Bulletin No.: 02-06-04-037J

Date: March 20, 2012

Subject: Check Engine Light On, Fuel Tank Hard to Fill, DTCs P0442, P0446, P0455 or P0449 Set (Replace Evaporative Emission (EVAP) Vent Valve Solenoid Assembly and Add/Relocate Filter Box Using Service Kit)

Extended Cab Short Box Shown Below, Other Configurations Similar

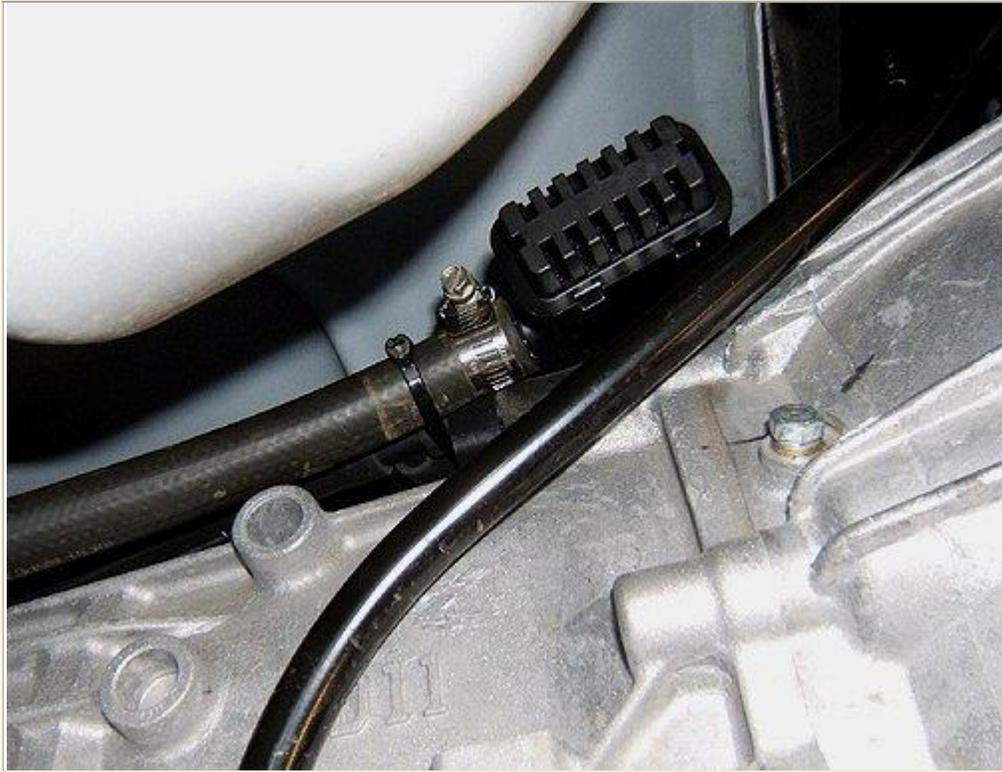
6. Install the new canister vent valve solenoid to the fuel tank clip or mounting bracket as shown above. The valve port closest to the electrical connector must point towards the canister.
7. Cut bulk 5/8" [heater hose](#) to a length of approximately 76 mm (3 in). Install the hose between the solenoid and the canister pipe and secure using clamps.
8. Attach bulk 5/8" [heater hose](#) to the vent port and secure using a clamp. Run a length as needed along the frame rail routing to the area above the transmission.
9. Cut the hose to determined length and install the supplied filter box. Secure using a clamp.
10. Remove the transmission support and lower the transmission assembly as necessary to allow for access to the new filter box location.

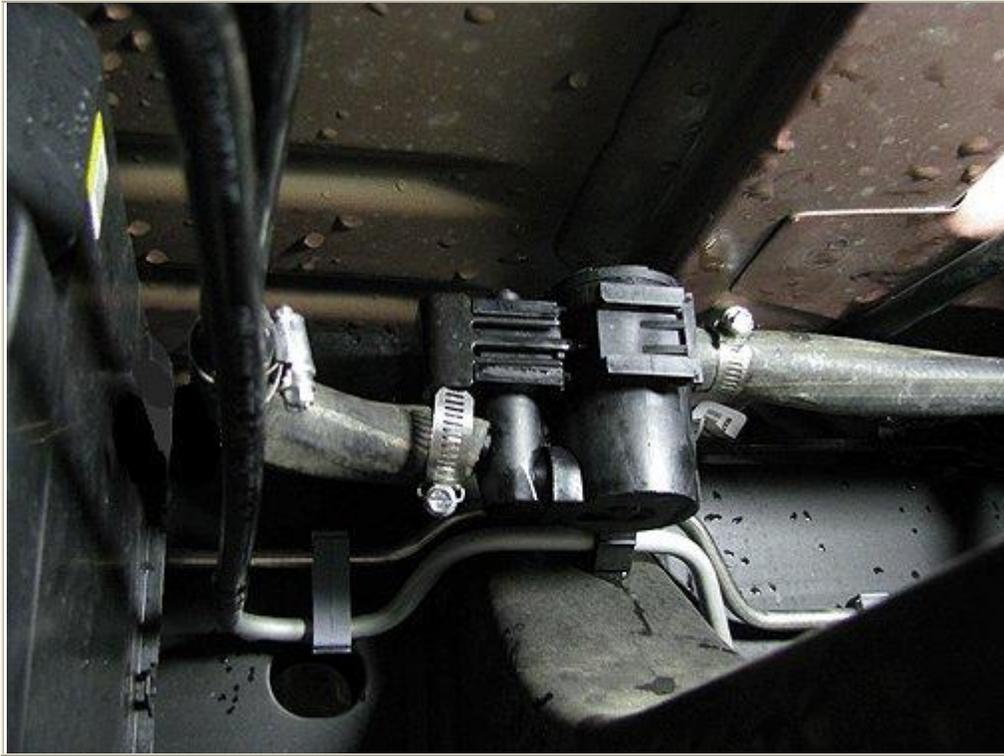
After following the published SI diagnostics and determining that the EVAP canister vent valve is the cause of the [MIL](#) light, replace the EVAP canister vent valve assembly and relocate the remote filter box. To ensure correct installation, follow the procedures below.

1. Raise the vehicle. Suitably support the vehicle.
2. Disconnect the EVAP canister vent valve electrical connector.
3. Disconnect the vent valve pipe quick connect from the canister.
4. Either cut the existing valve vent pipe and leave the remaining section of pipe in the vehicle or remove along with the valve.
5. Push in the retainer and remove the existing canister vent valve from the fuel tank clip or mounting bracket.
6. Cut back the existing canister pipe approximately 51 mm (2 in) and retain the pipe for use with new valve.
7. Connect the canister pipe quick connect to the canister.

1500 Extended Cab Short Box Shown Below, Other Configurations Similar

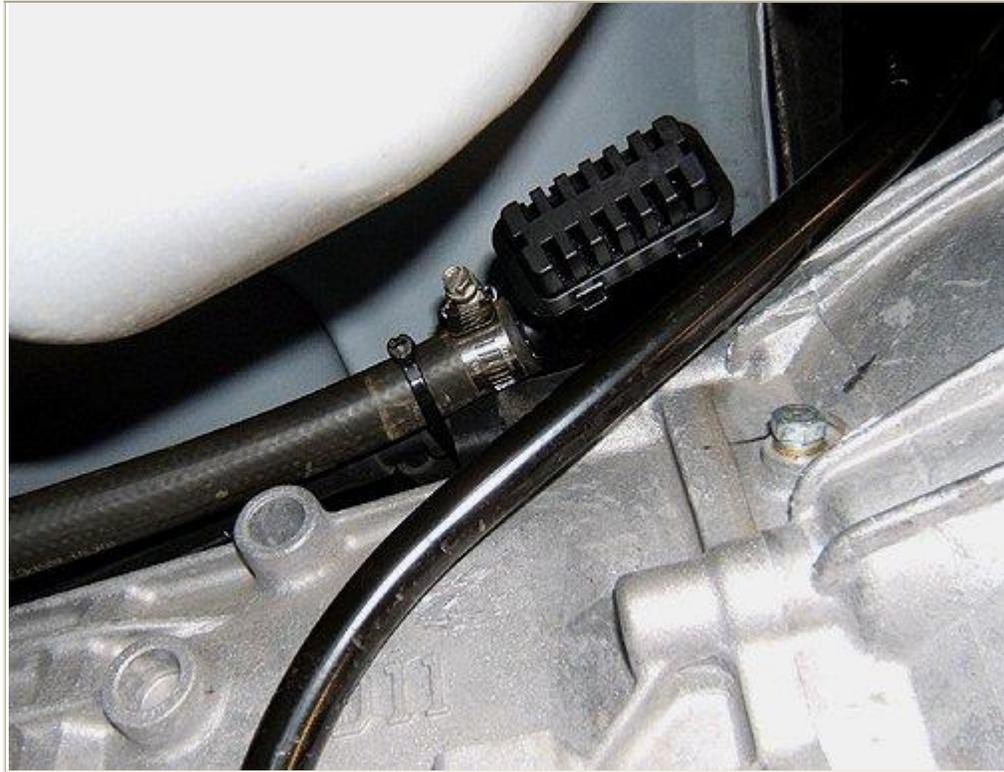
8. Install the new canister vent valve solenoid to the fuel tank clip or mounting bracket as shown above. The valve port closest to the electrical connector must point towards the canister.
9. Cut bulk 5/8" [heater hose](#) to a length of approximately 76 mm (3 in). Install the hose between the solenoid and the canister pipe and secure using clamps.
10. Attach bulk 5/8" [heater hose](#) to the vent port and secure using a clamp. Run a length as needed along the frame rail routing to the passenger side area above the transmission.
11. Cut the hose to determined length and install the supplied filter box. Secure using a clamp.
12. Remove the transmission heat shield, if necessary.
13. Remove the transmission support and lower the transmission assembly as necessary to allow for access to the new filter box location.

14. Secure the filter box to the transmission vent hose just forward of the hose tee-section using a tie strap. DO NOT pinch or restrict the transmission vent hose. The filter box opening should be pointing downward.
15. Raise the transmission and reinstall the transmission support.
16. Reinstall the transmission heat shield.
17. Connect the EVAP canister vent valve electrical connector.
18. Tie strap the hose as needed along the frame rail in order to keep the hose away from pinch-points and heat sources.
19. Lower the vehicle.
